SUBJECT: ISSUANCE OF AMENDMENT FOR INDIAN POINT NUCLEAR GENERATING UNIT NO. 3 (TAC NO. M96086)

ISSUANCE OF AMENDMENT NO. 170 TO FACILITY OPERATING LICENSE NO. DPR-28

AMENDMENT TO FACILITY OPERATING LICENSE

Amendment No. 170
License No. DPR-64

FIGURE 2.1-1

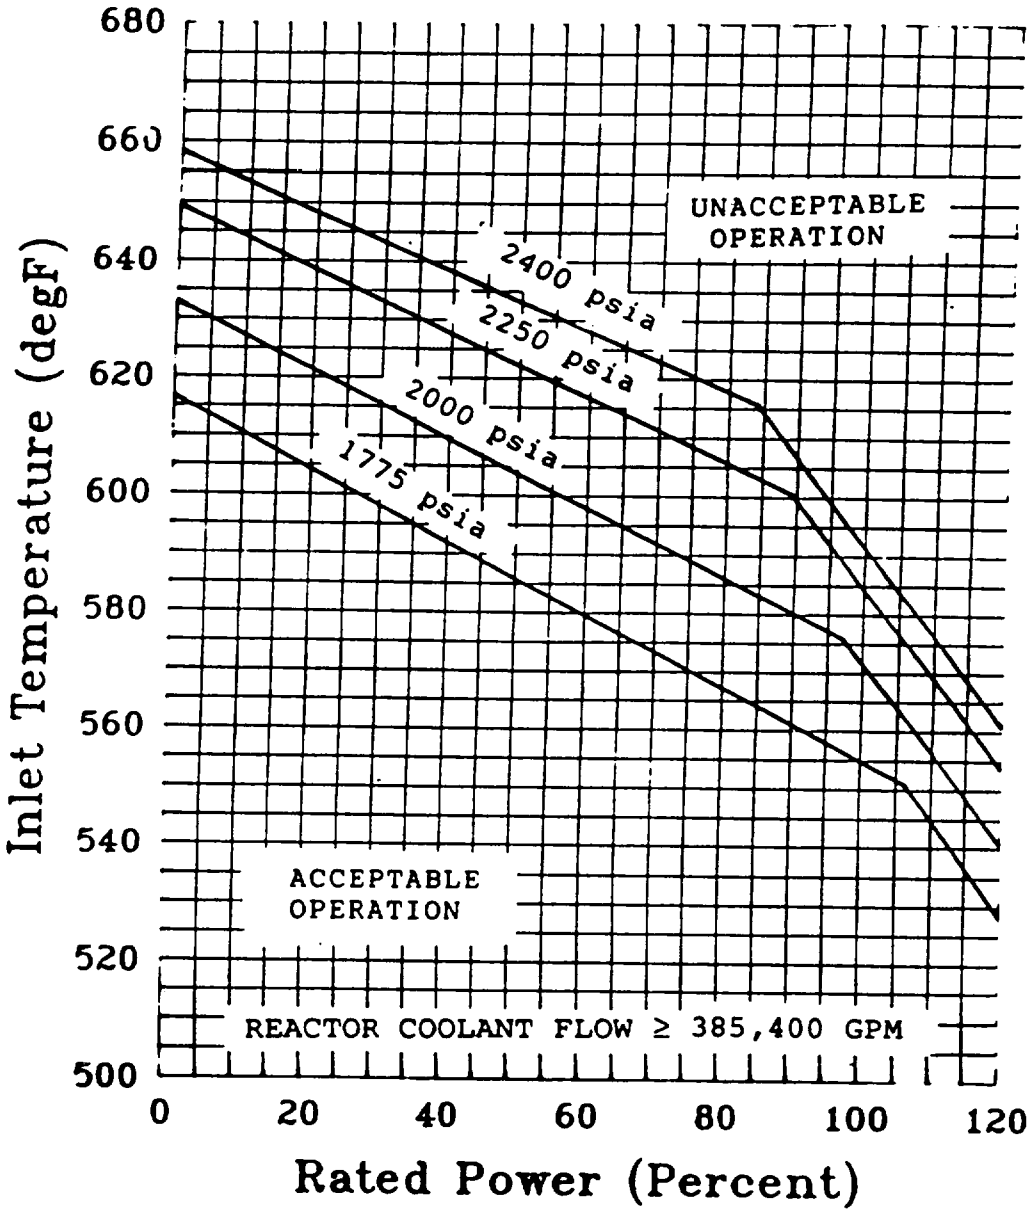
The curves of Figure 2.1-1 show the loci of points of thermal power, Reactor Coolant System pressure and vessel inlet temperature for which the calculated DNBR is no less than the Safety Limit DNBR value or the average enthalpy at the vessel exit is less than the enthalpy of saturated liquid.

Figure 2.1-1 includes an allowance for an increase in the enthalpy rise hot channel factor at reduced power based on the expression:

When flow or $F_{\Delta H}$ is measured, no additional allowances are necessary prior to comparison with the limits presented. A 2.6% measurement uncertainty on Flow and a 4% measurement uncertainty of $F_{\Delta H}$ have already been included in the above limits.

1. $F_{\Delta H}^{RTP} = F_{\Delta H}^{N}$ limit at Rated Thermal Power (RTP) specified in the COLR.

2. an equivalent steam generator tube plugging level of up to 30% in any steam generator provided the equivalent average plugging level in all steam generators is less than or equal to 24%,

3. a reactor coolant system total flow rate of greater than or equal to 385,400 gpm as measured at the plant,

4. a reference cosine with a peak of 1.55 for axial power shape.
